Proposal for amendments to UN Regulation No. 130 – Lane Departure Warning System (LDWS)

This document proposes an amendment to the original text of United Nations Regulation No. 130 – Lane Departure Warning Systems (LDWS). This proposal intends to facilitate effective functioning of the LDWS fitted to Australian supplied vehicles of category M₂, M₃, N₂ and N₃ primarily used under highway conditions.

Visible lane marking identification

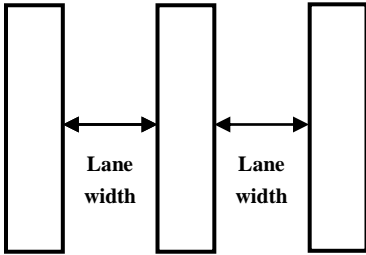
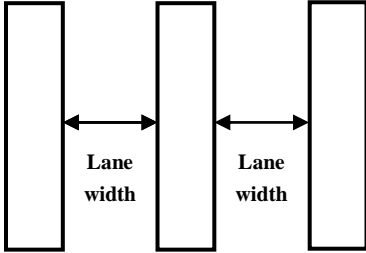
Annex 3., amend to read:

1. The expert from Australia proposes to include amendments to Annex 3 of UN Regulation No. 130 to account for Australian-specific lane marking identification ensuring vehicles will be designed for operation in the Australian market.

- Detect edge line or outline markings of 15 or 20 cm thickness;
- Detect variations in longitudinal gaps between lane markings ranging from a minimum of 3 m to a maximum of 9 m; and
- Detect unique Australian barrier lines separated by a 10 cm lateral gap between the 10 cm thick dividing lines.

6. There are vacant rows located between the lane marking information for Greece and Italy, and Italy and Ireland. If there are no requirements for these vacant rows, they should be removed.

Pattern			Country	Width		
Left edge lane marking	Centre line	Right edge lane marking		Left edge lane marking	Centre line	Right edge lane marking
			Definition of lane width for the purpose of this Regulation			
 <p>Undivided road with one lane each way</p>			AUSTRALIA Two-lane, two-way road

Pattern			Country	Width		
Left edge lane marking	Centre line	Right edge lane marking		Left edge lane marking	Centre line	Right edge lane marking
			Definition of lane width for the purpose of this Regulation			
<p>Central dividing line on an undivided road with more than one lane each way</p>			AUSTRALIA Multi-lane undivided road			
			AUSTRALIA Two-lane, two-way road with lane changing allowed from one direction only			
			AUSTRALIA Two-lane, two-way road with lane changing not allowed

Pattern			Country	Width		
Left edge lane marking	Centre line	Right edge lane marking		Left edge lane marking	Centre line	Right edge lane marking
			Definition of lane width for the purpose of this Regulation			
			AUSTRALIA Single barrier line			
...
